Item Name: Baggage Compartment Protector -Floor And Wall

DART SERVICE INSTRUCTION

TO AMEND INSTALLATION INSTRUCTIONS IIN-D407-781-2 REV. A OR LATER APPROVED REVISION
AND INSTRUCTIONS FOR CONTINUED AIRWORTHINESS ICA-D407-781 REV. 3 OR LATER REVISION

A	NEW ISSUE		13.04.08
REV.	DESCRIPTION	BY	DATE
DESIGN			
DRAWN			
CHECKED			
MFG. APPR.	N/A		
APPROVED			
DE APPR.			
DATE	13.04.08		
DART AEROSPACE LTD HAWKESBURY, ONTARIO, CANADA		REV. A SHEET 1 OF 2	
DRAWING NO. DSI 9649		SCALE NTS	
TITLE ALTERNATE INSTALL			
COPYRIGHT © 2013 BY DART AEROSPACE LTD. THIS DOCUMENT IS PRIVATE AND CONFIDENTIAL AND IS SUPPLIED ON THE EXPRESS CONDITION THAT IT IS NOT TO BE USED FOR ANY PURPOSE OR COPIED OR COMMUNICATED TO ANY OTHER PERSON WITHOUT WRITTEN PERMISSION FROM DART AEROSPACE LTD.

**FIGURE 1 - D3879-1 BAGGAGE COMPARTMENT WALL
PROTECTOR - ALTERNATE INSTALLATION**

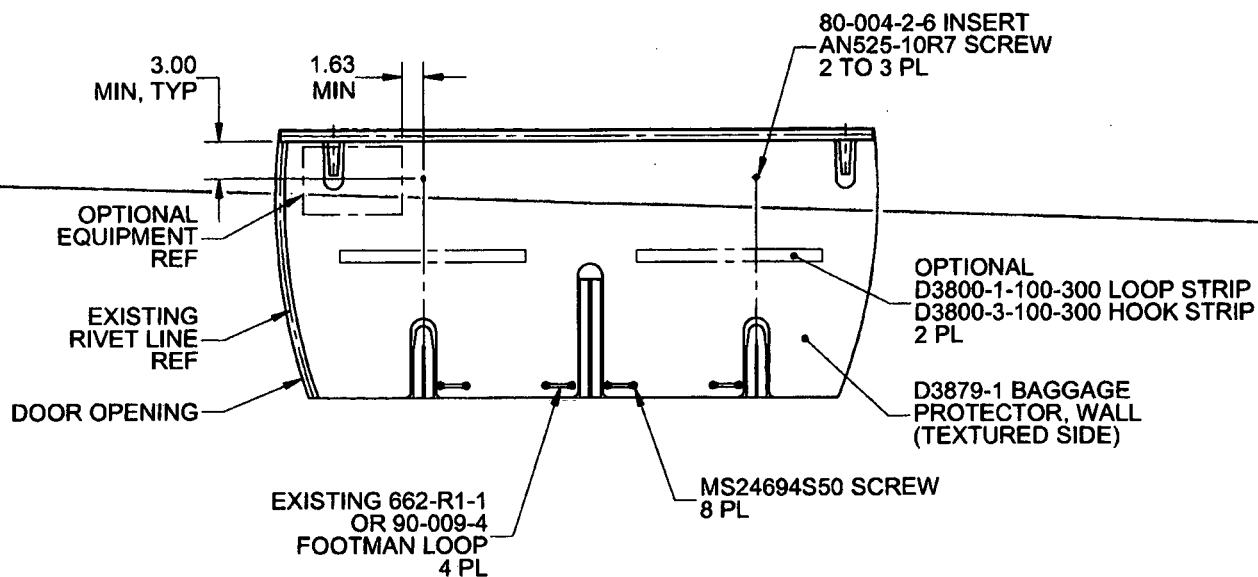
In some aircraft, the top portion of the D206-781-041 Baggage Compartment Wall Protector Kit cannot be installed as indicated in IIN-D407-781-2. The purpose of this DSI is to provide an alternate mounting method to fasten the top portion of the D206-781-041 Baggage Compartment Wall Protector Kit.

It is acceptable to replace qty(2) D3930-1 Clips with qty(2) 80-004-2-6 Inserts. Locate and mark location of the two attachment holes on the baggage compartment wall as shown in Figure 1 of this service instruction. Install 80-004-2-6 Inserts at the marked locations in accordance with Section 3-2-12 of BHT-206-SRM-1. It is acceptable to trim the wall protectors to accommodate optional equipment or transfer attachment holes to the wall protector and install the optional equipment on top of the wall protector with longer fasteners.

Amend the D206-781-041 Baggage Compartment Wall Protector Kit parts list as follows:

Qty -061	Qty -031	Qty -041	Part Number	Description
X			D206-781-061	BAGGAGE COMPARTMENT PROTECTOR KIT (FLOOR AND WALL)
1	X		D206-781-031	BAGGAGE COMPARTMENT FLOOR PROTECTOR KIT
1		X	D206-781-041	BAGGAGE COMPARTMENT WALL PROTECTOR KIT
		2	AN525-10R7	SCREW
		2	80-004-2-6	INSERT
